BLM SCALAR FIX -Based on findbhudda's original design:
http://www.midibox.org/dokuwiki/doku.php?id=findbuddha

DESIGN FILES:
Corrected blm-scalar v1.1.brd bellow & attached blm-scalar_v1.1.brd.zip

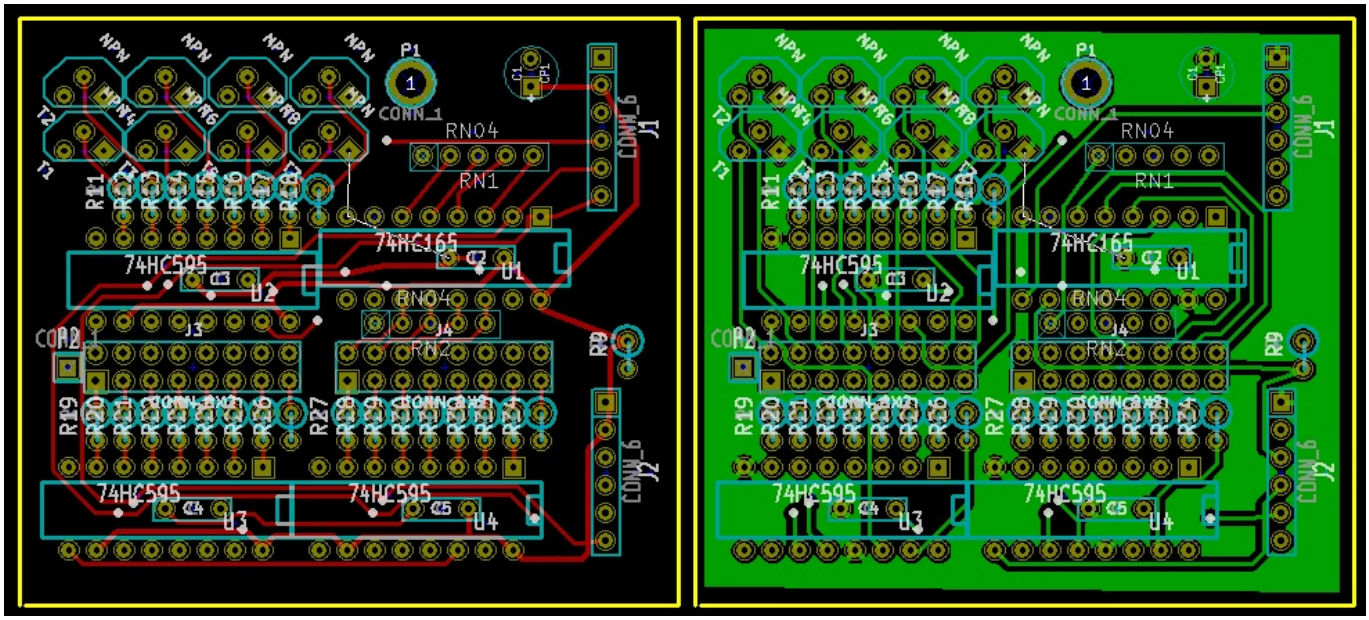
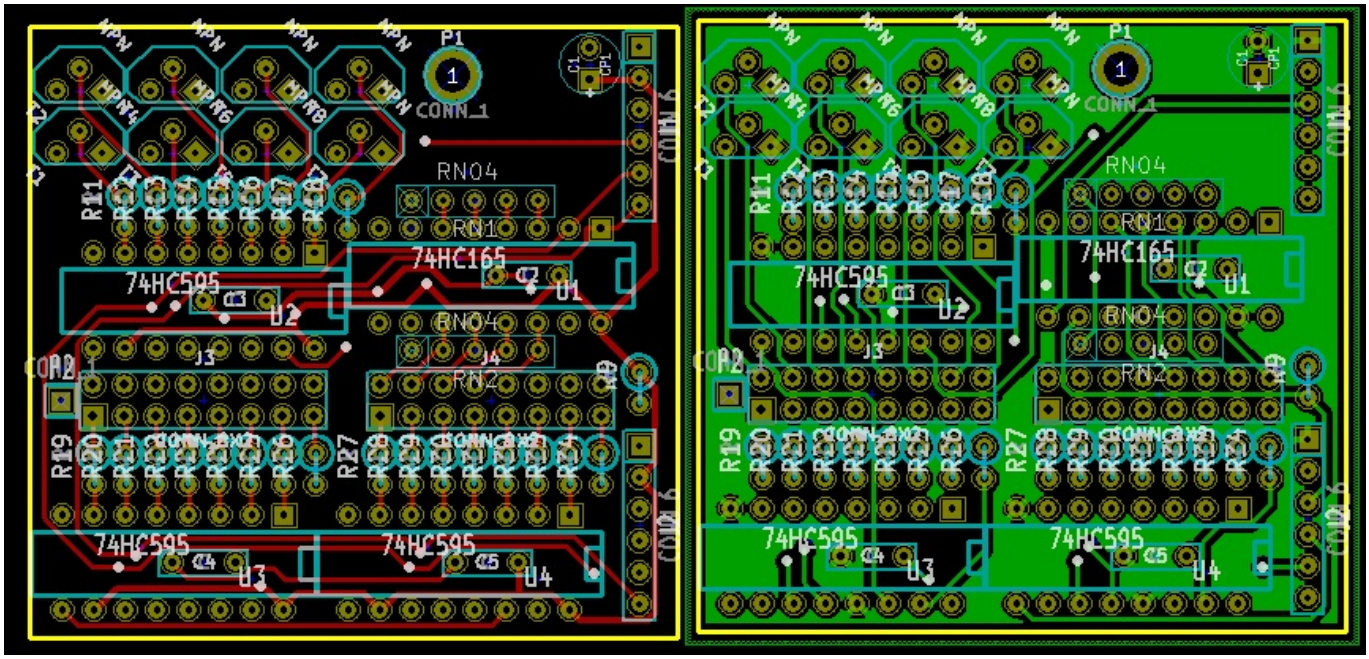
KNOWN ISSUES / BUILD SUGGESTIONS:
- blm-scalar.* contain an error. Pins I4-I7 are mirrored. This is easily fixed with a connector modification, and the blm-scalar module seems to work as intended.
- blm-scalar v1.1 attempts to fix this error. Moved connectors J1, J2, Resistor Net 1 and R9 to make room for corrections.
